### REMARKS

Reconsideration of this application, based on this amendment and these following remarks, is respectfully requested.

Claims 1 through 7 and 11 through 15 are now in this case. Claims 8 through 10 are canceled. Claims 11 through 15 are added.

FIG. 1  
 PRIOR ART

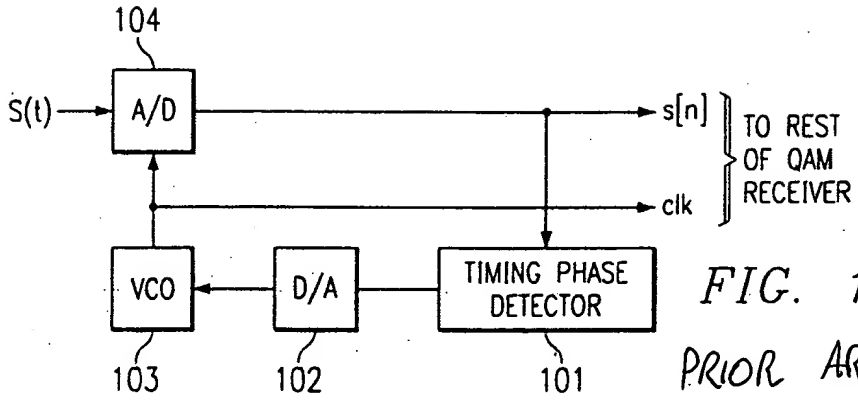
The drawings are amended to insert the "PRIOR ART" designation in Figures 1 and 2, which the Examiner found lacking. Applicant submits that this amendment to the drawings overcomes the objection to the drawings.
